UNITED STATES
NUCLEAR REGULATORY COMMISSION
WASHINGTON, D. C. 20555

Docket Nos. 50-329
and 50-330 OM, OL

APPLICANT: Consumers Power Company
FACILITY: Midland Plant, Units 1 and 2
SUBJECT: SUMMARY OF OCTOBER 6-7, 1981 MEETING ON UNDERGROUND PIPING

To File 0485.16
From GSKeeley, P-14-113B
Date October 23, 1981
Subject MIDLAND PROJECT -
UNDERGROUND PIPING MEETING WITH -
STAFF ON OCTOBER 6 AND 7, 1981 -
FILE 0485.16 SERIAL 14704
Internal
Correspondence
CONSUMERS
POWER
COMPANY
G S Keeley
CC JWCook, P-26-336B (w/o att) DFLewis, Bechtel-AA (w/att)
AJBoos, Bechtel-AA (w/o att) MIMiller, IL&B (w/att)
JEBrunner, M-1079 (w/att) DESibbald, Midland (w/att)
WJCloutier, P-24-611 (w/att) DMBudzik/TJSullivan, P-24-624A (w/o)
~~Roger Huston, Washington (4 copies w/all)~~

INSERVICE TESTS - LEAKAGE TESTS

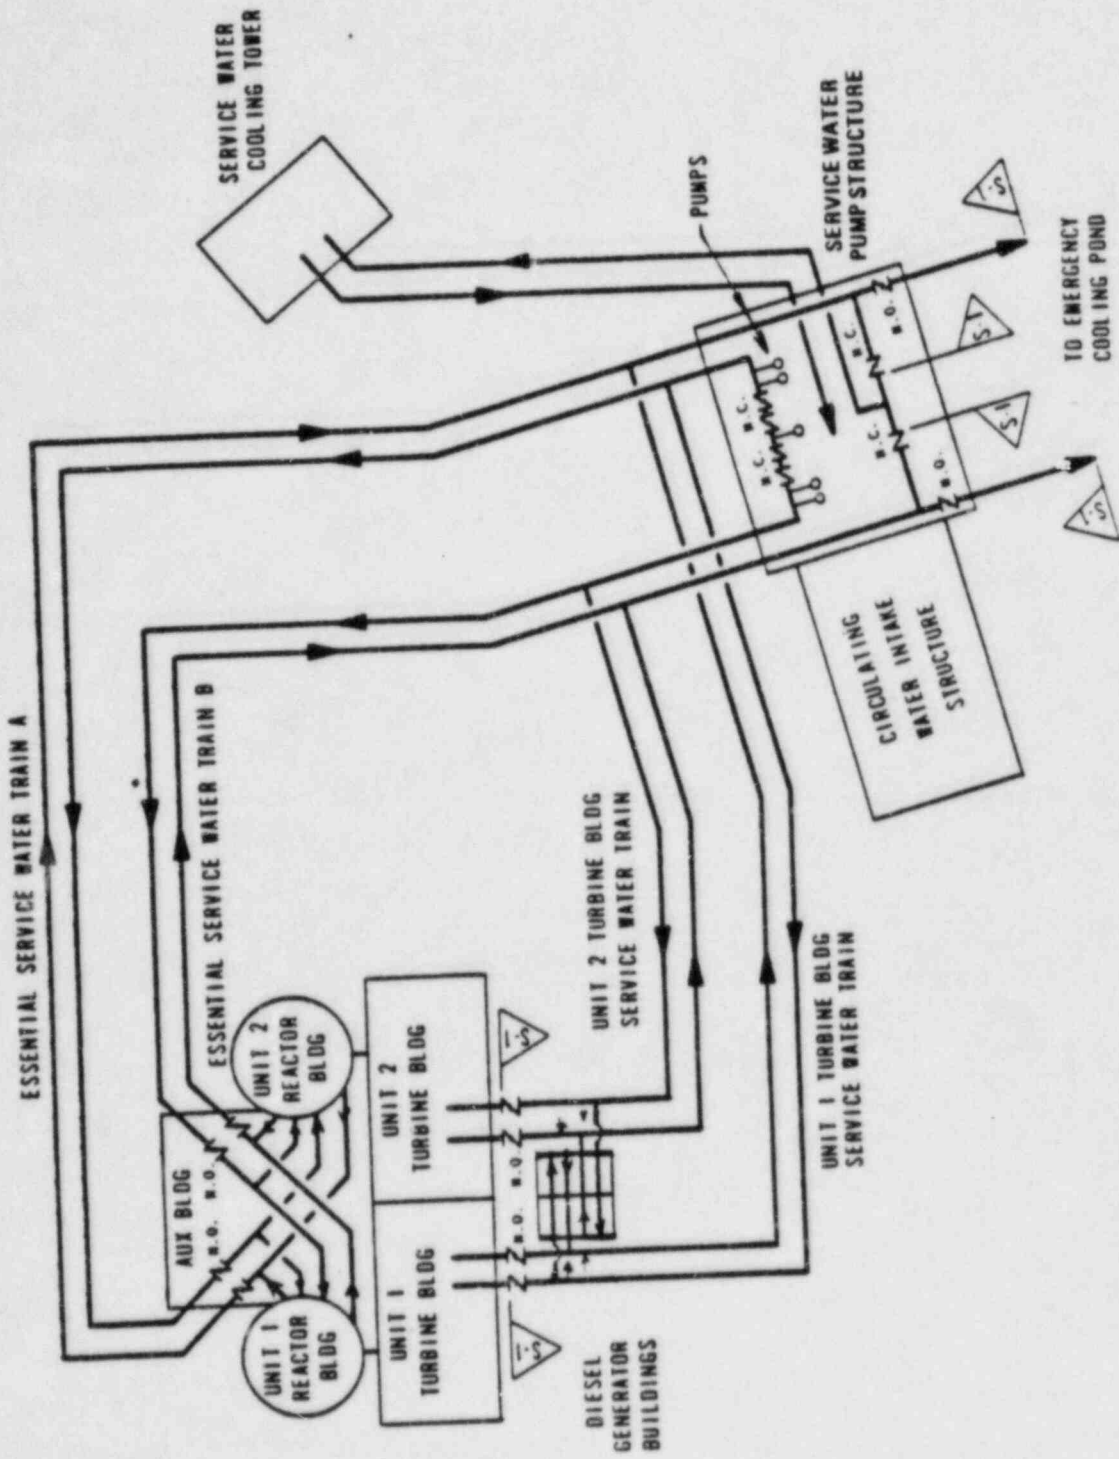
D Gupta and A Cappucci (NRC) questioned the appropriateness of this type of testing. Their concern is that small deformations go undetected. It is not apparent that pipe deformation could not progress so far by the time any flow effect is noted that collapse might be imminent. Such collapse might then occur between testing periods and go undetected for some period.
